ISSUE with: 2 x GTX TITAN Z's on a MSI X99S Gaming 9 Motherboard - System should also read 4 x GPU's

MSI X99S Gaming 9 AC

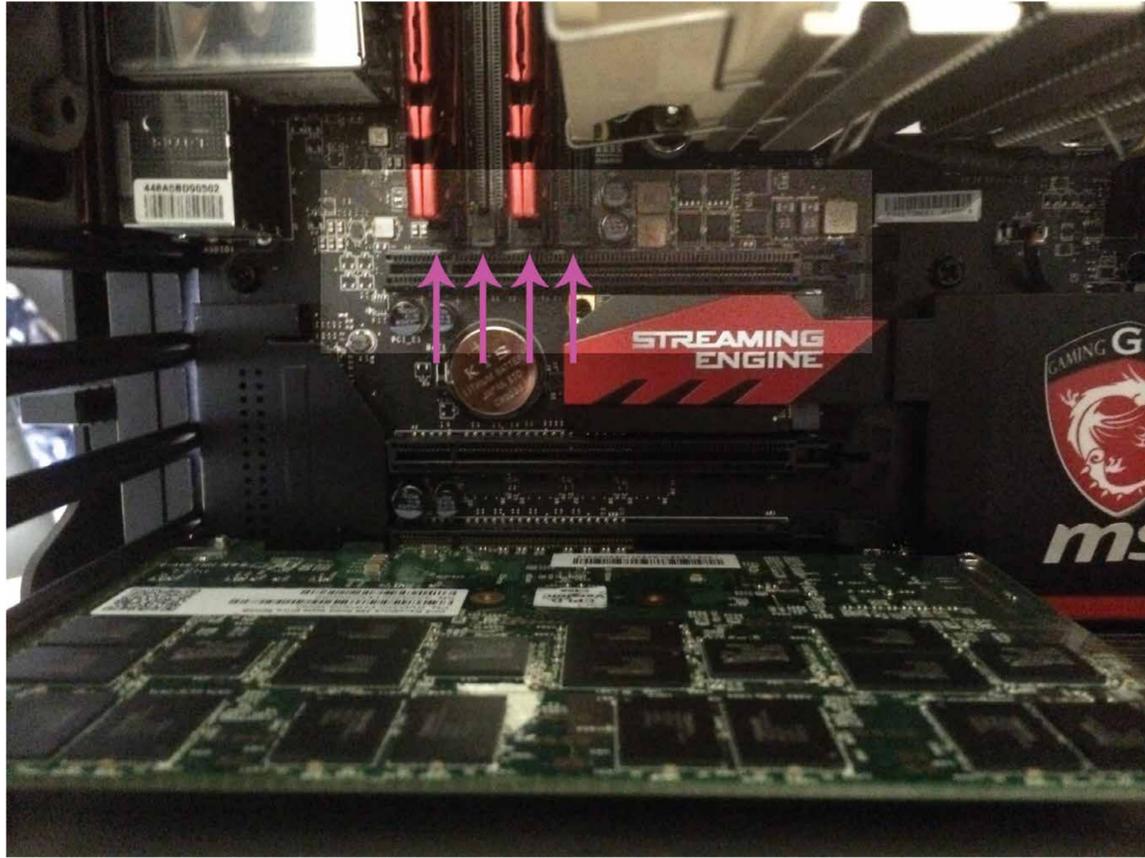
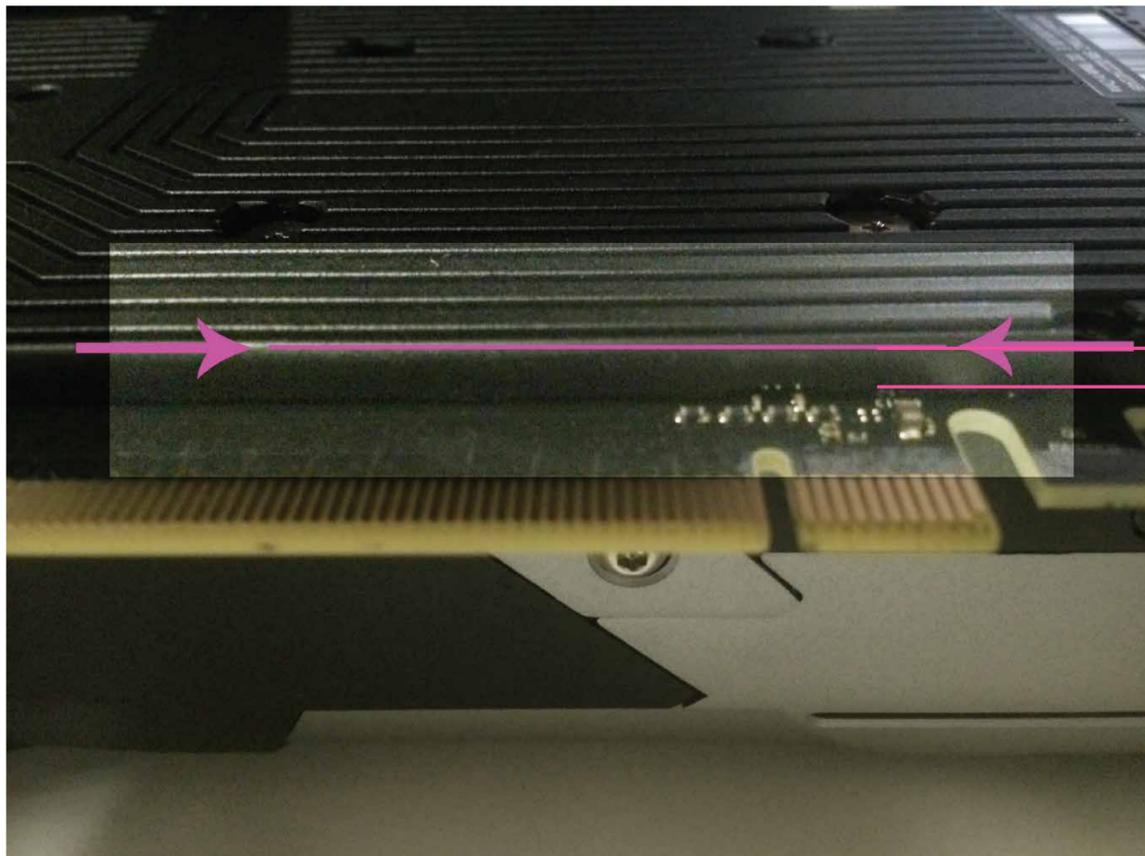
Part 1 & 2 are colliding by a max. of 1.5mm and this will not allow for the GPU to be correctly seated on the X99S Gaming 9 Motherboard.

2 x GTX Titan Z will not fit on this motherboard without a modification required to either the GTX Titan Heat Sink or the Plastic Support Brackets for the Ram modules.
